***MODIFICATION REQUEST:  
Stages 2 and 3, Site 3 Mixed Use  
Development  
Australia Avenue, Sydney Olympic Park  
(MP 10\_0027 MOD 1)***

***Modifications to Tower 1 floor layouts***

Director-General's  
Environmental Assessment Report  
Section 75W of the  
*Environmental Planning and Assessment Act 1979*

Figure 1: Approved North Elevation

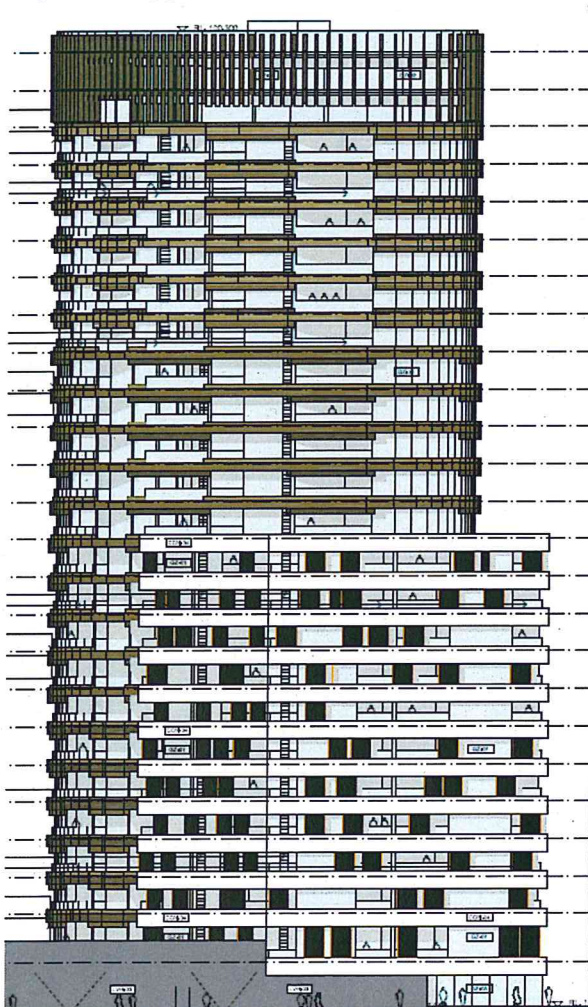
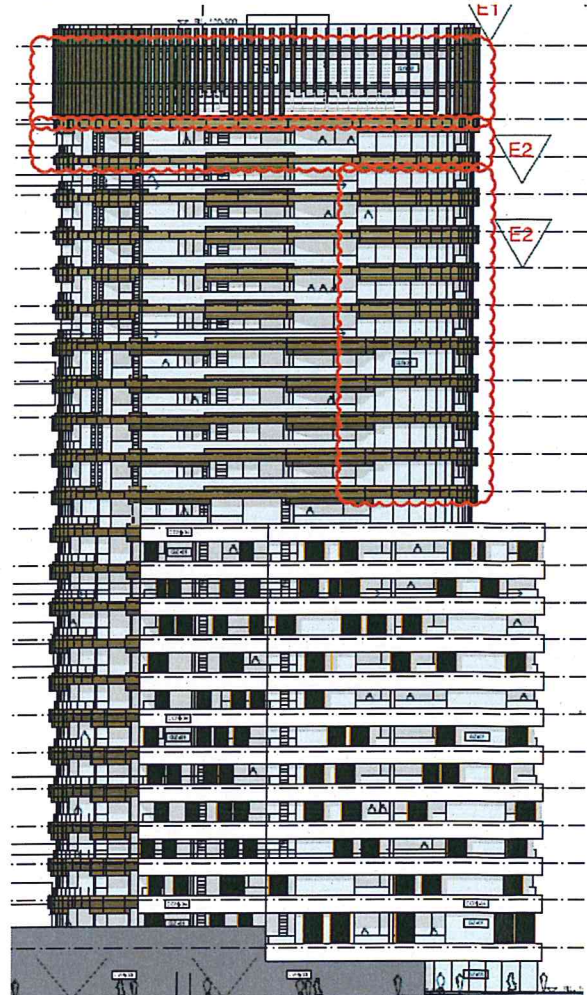
The proposal modifies the layout of the upper levels of Tower 1 to increase the number of one and two bedroom apartments. Whilst there would be an increase in gross floor area (GFA) by 52 sqm as a result of reduction in some corridor space, slightly smaller balconies for some units, and infilling the voids at Level 24, the bulk and scale of the tower would remain generally the same. The appearance of the building will change as a result of the modified articulation with revised balconies, windows and materials due to the modified unit layouts. The amendments would be generally imperceptible from most views to the building and the balustrades and glazing elements would remain relatively unaltered along the elevations (see Figures 1-8).

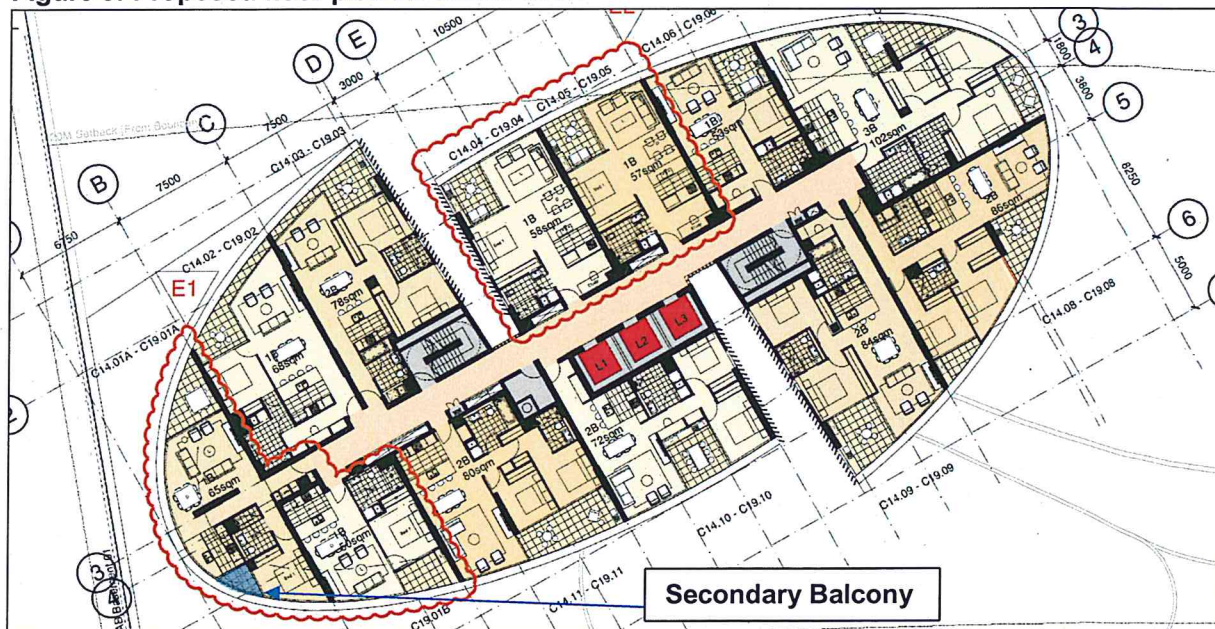
SOPA raised concerns regarding the ability of the modified proposal to achieve adequate levels of cross-ventilation and the functionality of some of the new balconies given their small size. The proponent has demonstrated that the units in Tower 1 and Tower 2 meet the minimum 60 per cent of units required in the RFDC to be cross-ventilated. Whilst SOPA identified the size of some of the new balconies (see Figure 9) as being dysfunctional due to their size, the department considers that they are acceptable as they are secondary balconies and the primary balconies meet RFDC guidelines. Furthermore, balconies of a similar size and design were previously included in the design of units within both the towers (see Figure 10) and were considered consistent with the RFDC guidelines, which promote the provision of secondary balconies.
